**CLARKE COUNTY PLANNING COMMISSION
TABLE OF CONTENTS
February 2, 2018 Business Meeting**

3. **S-17-01, Peter O. & Melanie M. Hitchen.** Request approval of a five-lot major subdivision for the property identified as Tax Map #30-A-65, located in the 4000 block of John Mosby Highway, White Post Election District zoned Agricultural Open-Space Conservation (AOC).

Re: *Coquette Estates Road Construction Plan*
Erosion and Sediment Control Plan Review (2nd Submittal)
H&P JN 20171813

Re: *Coquette Estates Road Construction Plan Subdivision Street Plan Review
(2nd Submittal)
H&P JN 20171813*

Coquette Estates Subdivision

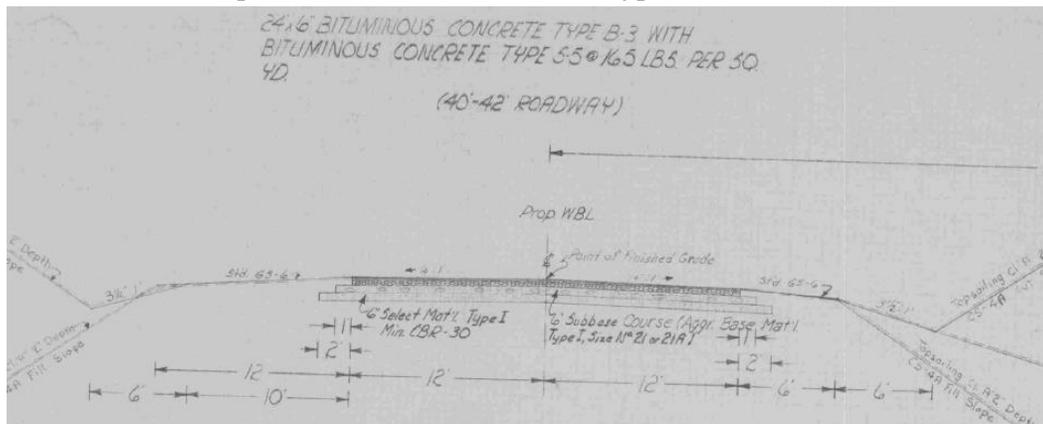
1. Show any adjacent and opposite side of roadway entrances. Provide distances to next adjacent entrance and nearest State highway intersections in each direction.

2. Identify required and available* unobstructed stopping sight distance and intersection sight distance and line of sight profiles at all entrance(s). (*show the maximum available sight distance and not minimum required.) Provide sight distance easements where line of sight leaves right-of-way.

3. Specify VDOT entrance Standard CG-11.
4. Provide entrance profile from center line of roadway with grading in accordance with the specified proposed VDOT standard entrance type. Slope the entrance away from Route 17/50 for 12' width to accommodate future taper or turn lane, normal shoulder and positive drainage. Adjust grade going into site to accommodate.

5. Provide typical section of entrance(s) and turn lanes including dimensions, cross slopes and pavement design. Match US Route 17/50 pavement to the right-of-way line. Below is the constructed pavement thickness from the typical section.

6. VDOT Standard WP-2 Pavement Widening Detail to be included on all plans. Show in plan view limits of mill and overlay per WP-2 Detail.
7. Drainage – show pipe sizes, lengths and material types (existing and proposed). Provide drainage computations in accordance with *VDOT Drainage Manual*. Provide proposed culvert/storm sewer profile. Show directional flow arrows of proposed and existing drainage to culverts, entrance(s) and adjoining State highways. Culvert extension will need to be on the same line and grade as existing culvert.

8. Show 4' shoulders on entrance radii and include adequate pipe length to obtain 4:1 slope from edge of shoulder to end of culvert. Maintain shoulder width and slope on US Route 17/50 per geometric design standards for this facility.
9. Make both sides of entrance radii 50'.
10. Provide current details with plan set of all VDOT Standards called for in design.
11. Provide signage, pavement markings, and cluster mailbox location on plan off VDOT right-of-way.
12. Provide current VDOT General Notes on plan cover sheet.
